Before the  
FEDERAL COMMUNICATIONS COMMISSION  
Washington, D.C. 20554

In re:	}	
	}	
Amendment of Section 73.202(b)	}	
Table of Allotments,	}	MM Docket No. 00-69
FM Broadcast Stations.	}	RM-9850
(Cheboygan, Rogers City, Bear Lake,	}	RM-9945
Bellaire, Rapid River, Manistique,	}	RM-9946
Ludington, Walhalla and	}	
Onaway, Michigan)	}

**OPPOSITION TO PETITION FOR RECONSIDERATION**

**STATEMENT OF WILLIAM J. GETZ  
IN SUPPORT OF AN OPPOSITION TO A  
PETITION FOR RECONSIDERATION  
IN MM DOCKET NO. 00-69  
RM-9850, RM-9945, RM-9946**

Exhibit 1 August, 2002

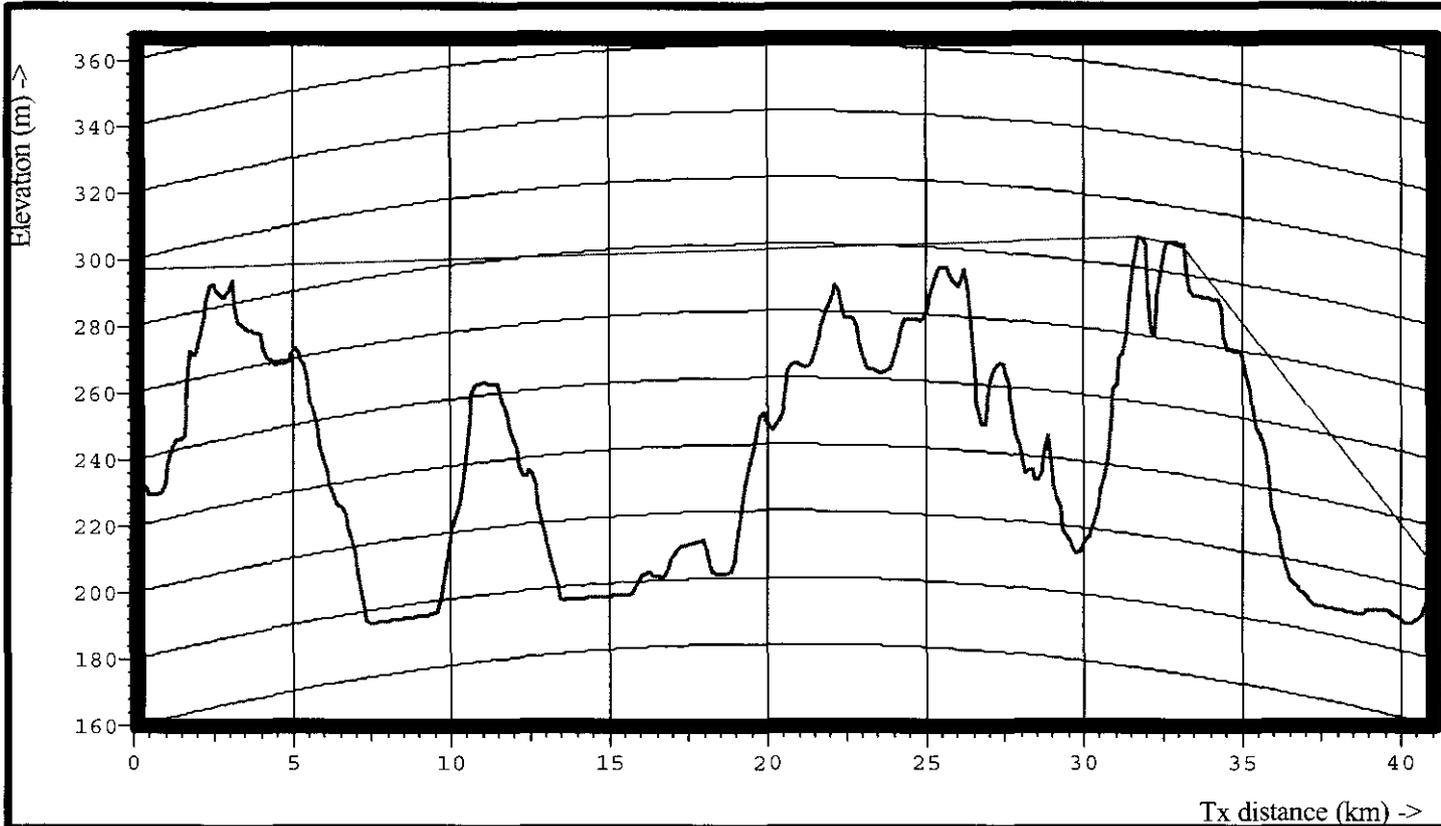
Exhibit 1 is the computer-generated terrain profile (using a 3-second terrain database) from the Channel 260C1 allotment reference site toward Bellaire which was originally submitted in Northern Radio’s September, 2000, Opposition. As Exhibit 1 clearly illustrates, because of the close proximity of a major terrain obstruction to Bellaire, the entire community

is terrain-shielded from the Fort Bend allotment reference site which is located over 25 miles away on a bearing of 9 degrees true from center-city Bellaire.

<sup>3</sup> The steep slope of the line-of-sight out of Bellaire toward Fort Bend's proposed allotment reference site, over the top of Dingle Hill, is clearly shown on Exhibit 1. It should be noted that Dingle Hill obstructs Bellaire from the entire Channel 260C1 permissible site area (i.e. there is no alternate, fully-spaced, allotment reference site on Channel 260C1 which could provide clear line-of-sight coverage to Bellaire from a tower of realistic height).

PROPOSED REFERENCE SITE TO COMMUNITY  
DIRECT RADIAL TERRAIN CHARACTERISTICS  
PROPOSED Ch. 260C1 - BELLAIRE, MICHIGAN  
AUGUST, 2002

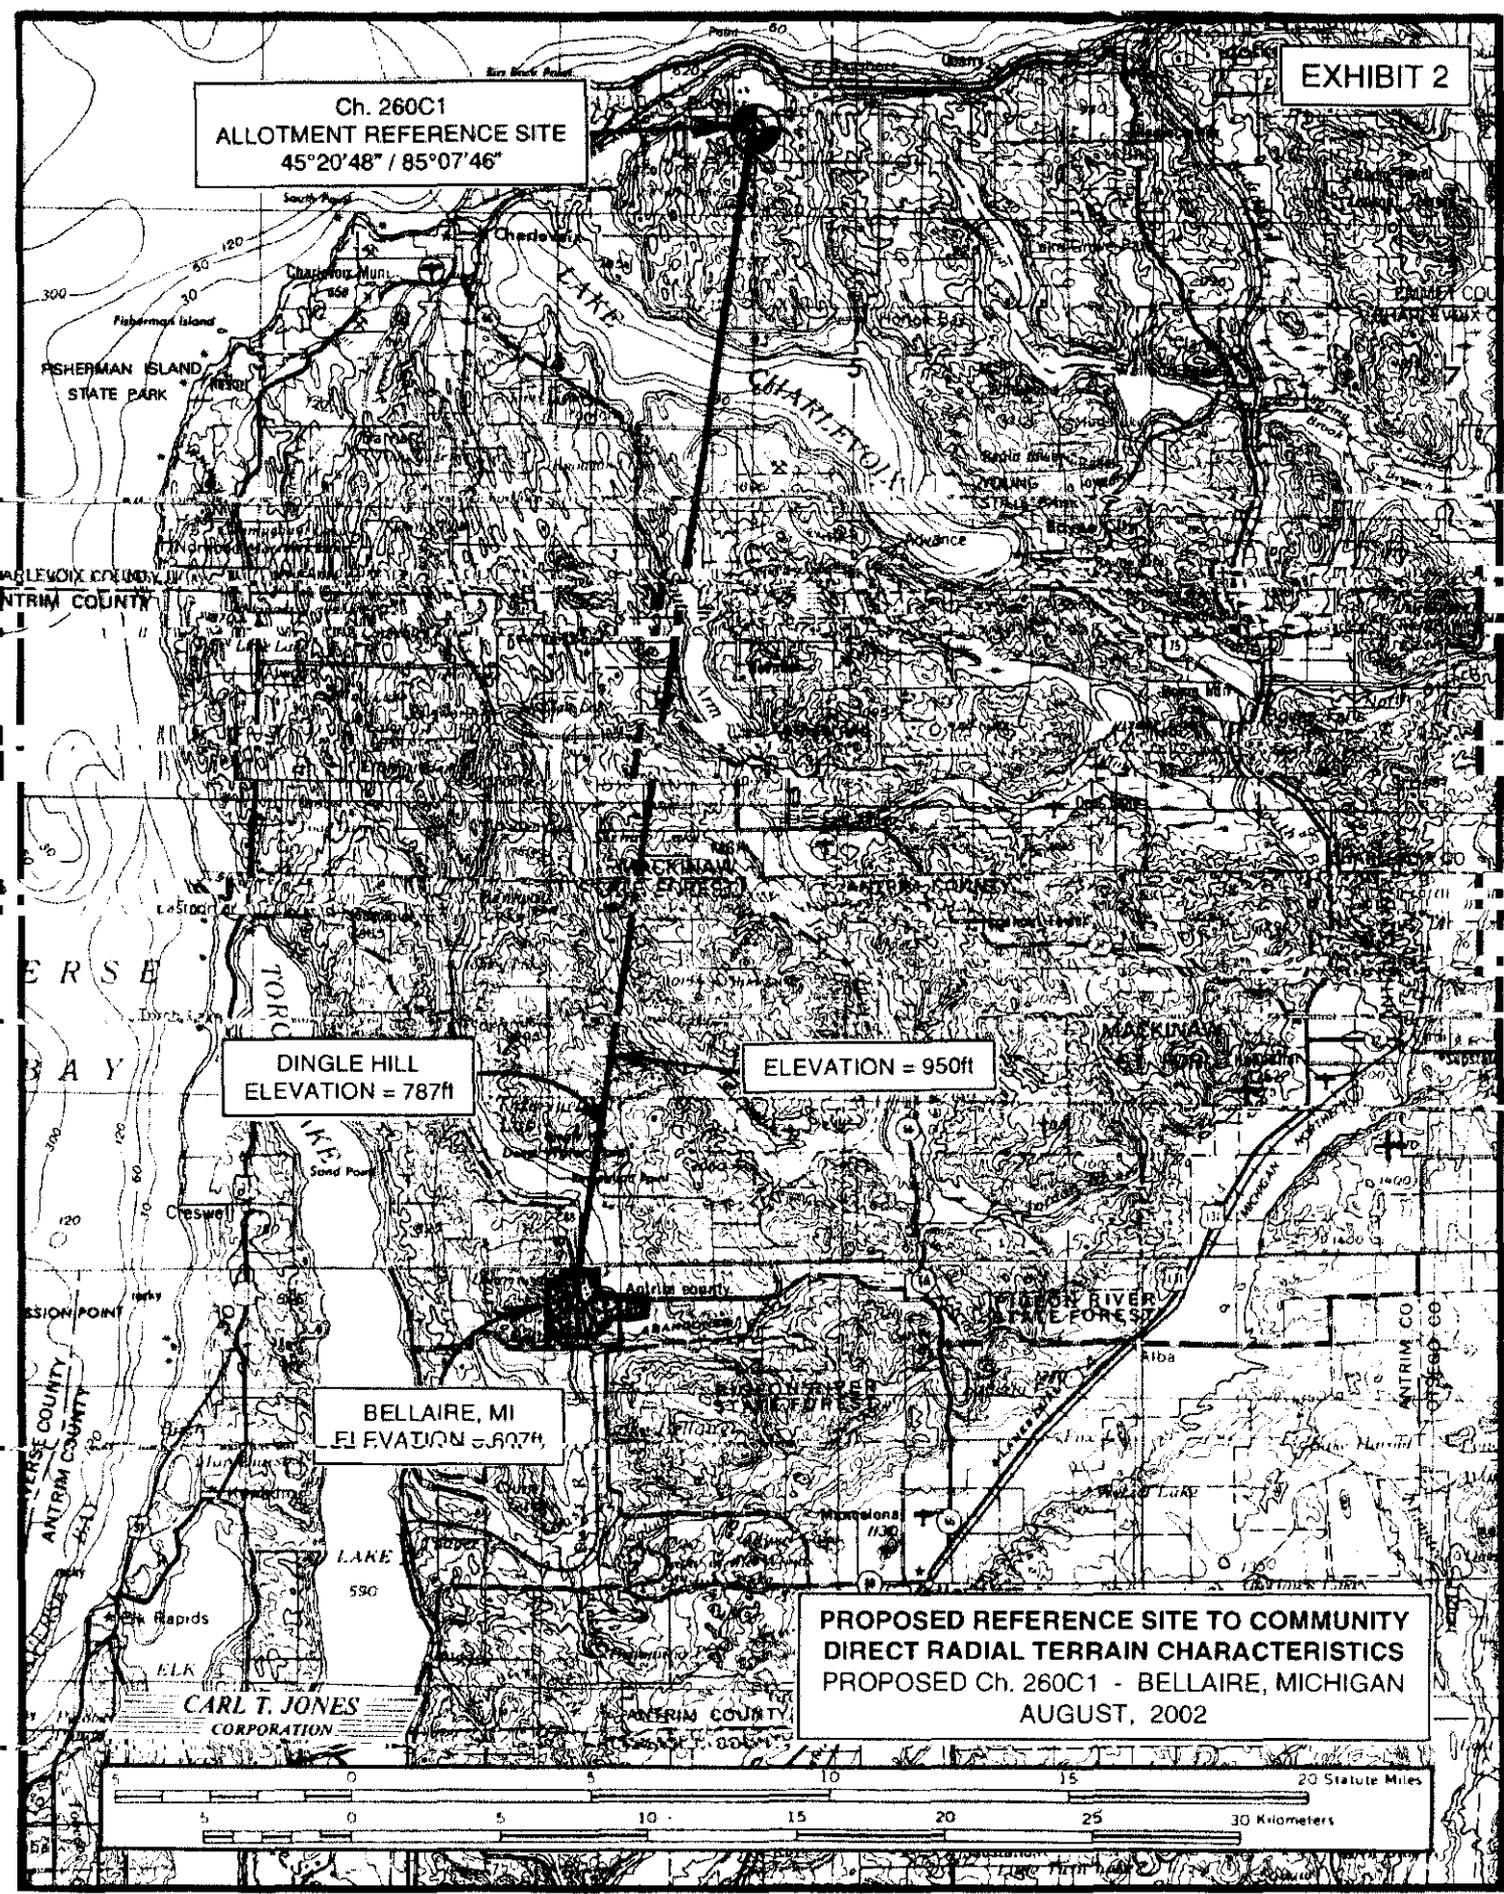
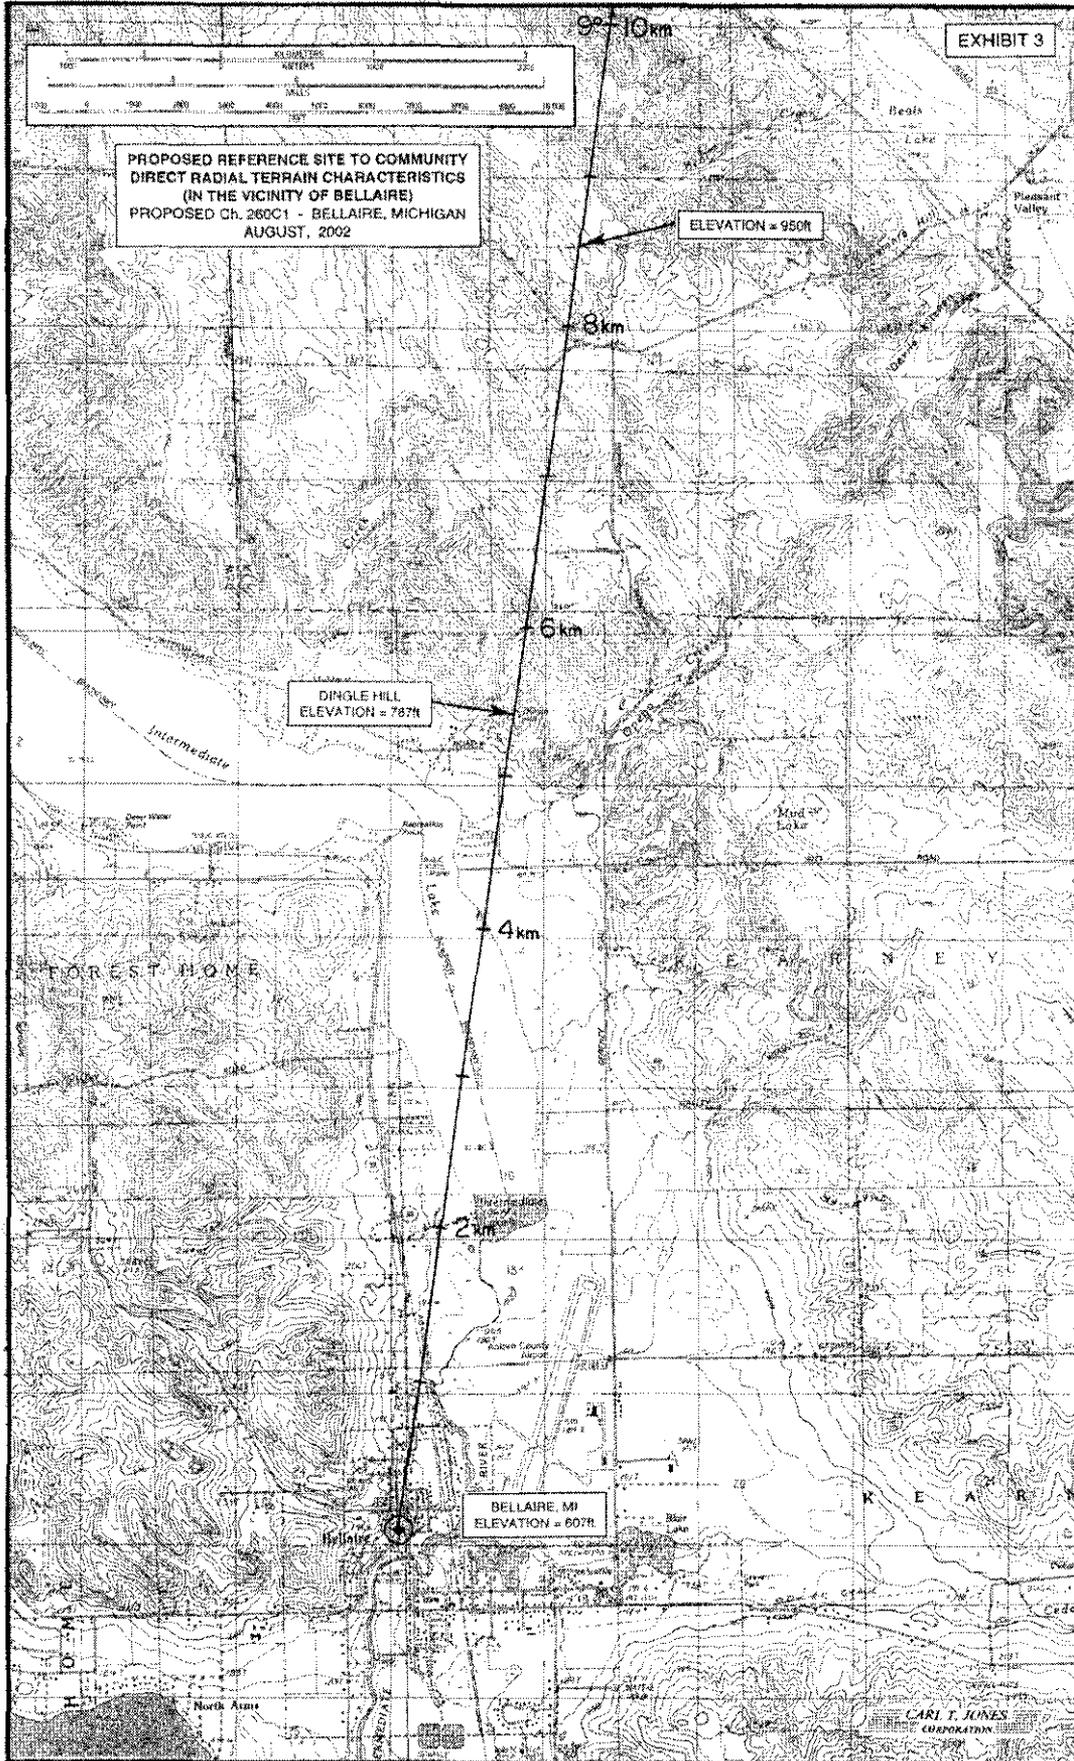
Exhibit 2 is a 1:250,000 scale U.S.G.S. map which shows the terrain characteristics of the entire path between the Fort Bend allotment reference site and Bellaire. The major terrain obstructions in the vicinity of Bellaire are labeled on Exhibit 2. Similarly, Exhibit 3 is a 7.5 minute topographic map (reduced for scanning) of the portion of the radial in the immediate vicinity of Bellaire. The same terrain obstructions labeled on Exhibit 2 are labeled on Exhibit 3.

Contrary to Fort Bend's assertion, the hills and mountains represented by the numerous terrain elevation contours on both Exhibits do not represent "terrain at a nearly constant elevation".<sup>4</sup> Rather, the terrain elevation contours represent widely varying terrain. Also contrary to Fort Bend's representation of the terrain, the terrain dips along the path do not only correspond to "lakes and waterways". The community of Bellaire is in one of those dips mentioned by Fort Bend as are state forest land and other land areas. Fort Bend may categorize the area between the allotment reference site and Bellaire as being free from terrain obstructions, having no hills and being at a constant terrain elevation, but the facts of the matter are: there exists a major terrain obstruction just outside of Bellaire known as Dingle Hill which effectively shields the entire community of license from the proposed allotment reference site; there area a number of hills and widely varying terrain along the path between the two sites; and, there are two downhill ski areas in the vicinity of the path between the Fort Bend allotment reference site and the community of Bellaire.

**PREDICTED CITY-GRADE COVERAGE CONTOUR  
 FROM CHANNEL 260C1 ALLOCATION REFERENCE SITE  
 ASSUMING TOWER HEIGHT OF 320 FEET ABOVE GROUND  
 CH. 260C1, 100 kW ERP, 117 m HAAT  
 AUGUST, 2002**

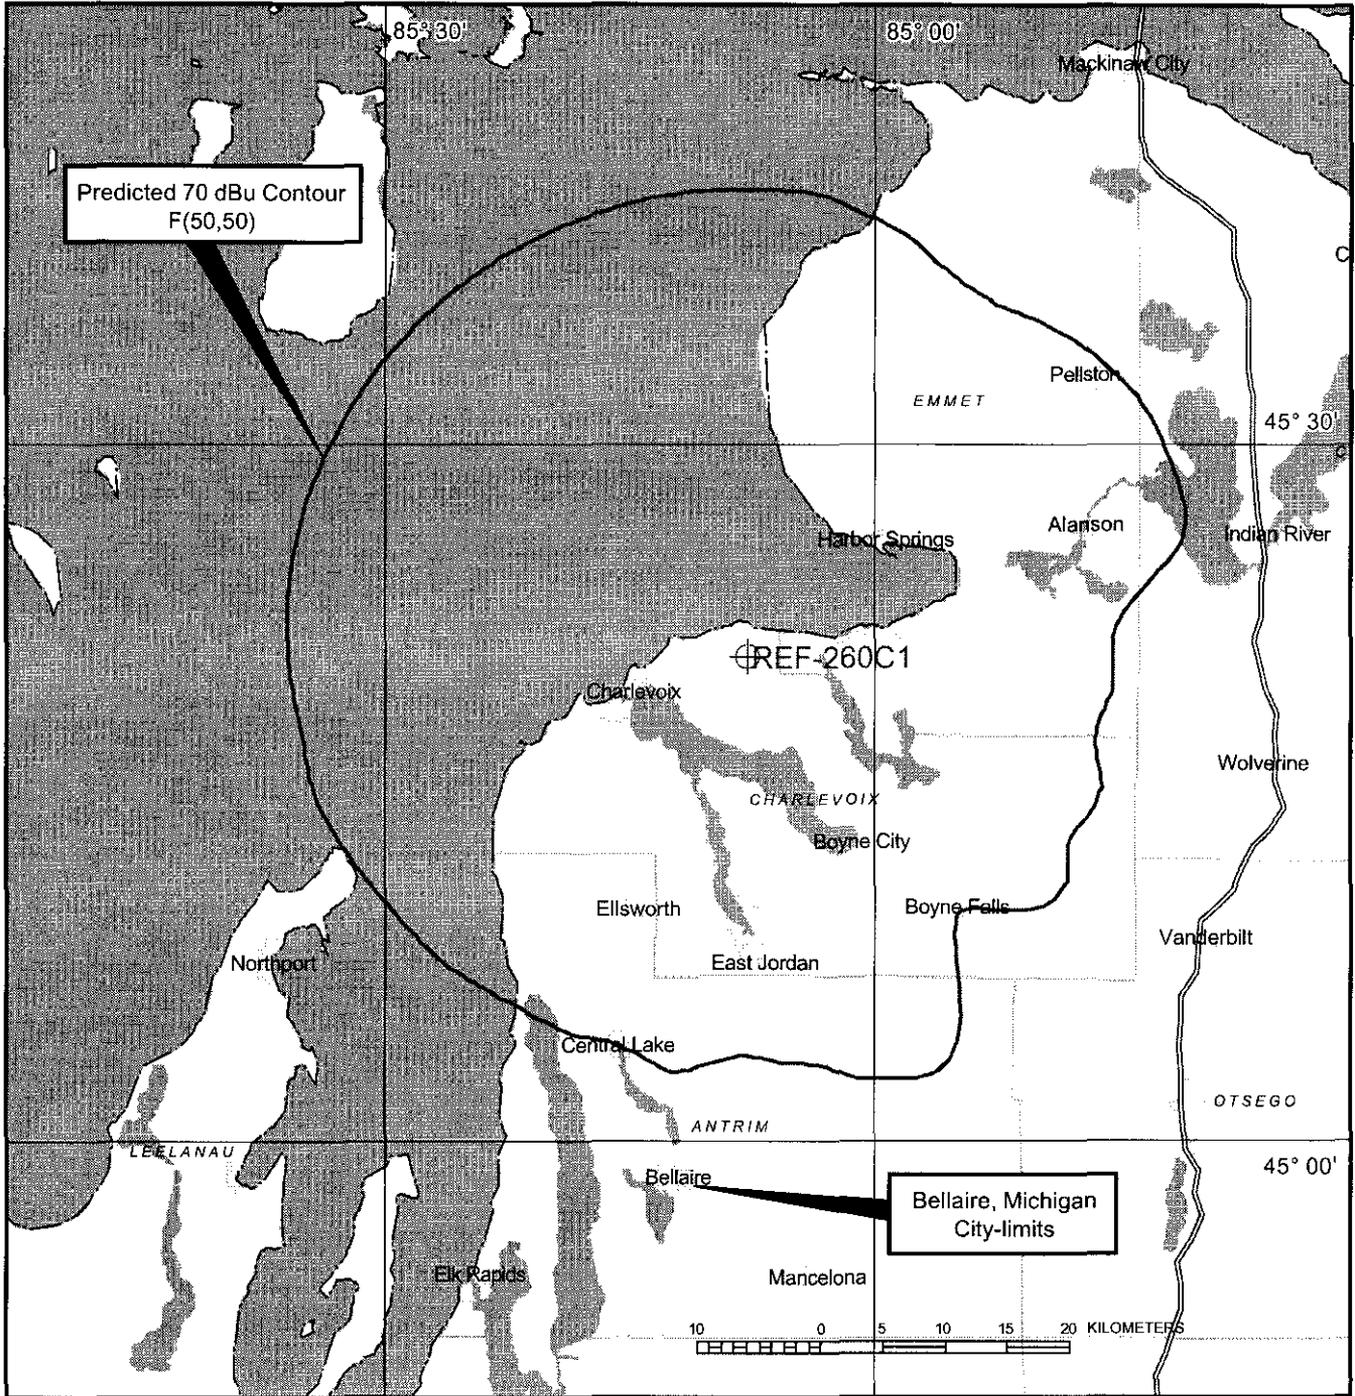
In its Petition for Reconsideration, Fort Bend submitted a Bellaire city-grade coverage study considering a 919 foot (280 meters) above ground level tower at the proposed allocation reference site. As stated earlier, a tower of 1,700 feet above ground level is necessary to satisfy Section 73.315(b) of the FCC Rules and any tower greater than 320 feet (97.5 meters) above ground level exceeds FAA obstruction standards. Exhibit 4, attached, is a city-grade contour coverage map from the proposed Channel 260C1 allotment reference site assuming a realistic tower height of 320 feet above ground level. As the map shows, the F(50,50) city-grade coverage contour covers no portion of the Bellaire city-limits.
